## REMARKS

### II. REJECTION OF CLAIMS 1, 2, 9, 10, 13 AND 14 UNDER 35 U.S.C § 102(a) AS BEING ANTICIPATED BY APPLICANT'S ADMITTED PRIOR ART (AAPA)

**AMENDMENTS TO THE DRAWINGS:**

FIG. 4 (PRIOR ART)

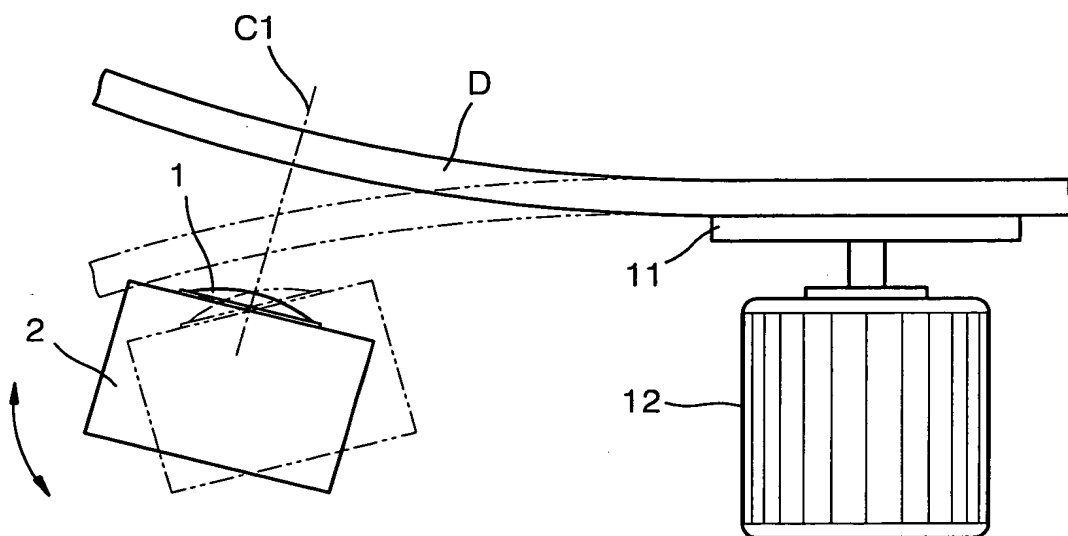
The attached drawing(s) include changes to FIGS. 4 and 5. The sheets containing FIGS. 4 and 5 replaces the original sheet including FIGS. 4 and 5. For the convenience of the Examiner, an annotated sheet showing the changes made is attached. Approval of these changes to the Drawings is respectfully requested. In the Office Action at item 2, the Examiner objected to the drawings. In order to overcome these objections, replacement figures are submitted herewith. In FIGS. 4 and 5, the words "PRIOR ART" were inserted. Approval of these changes to the Drawings is respectfully requested.
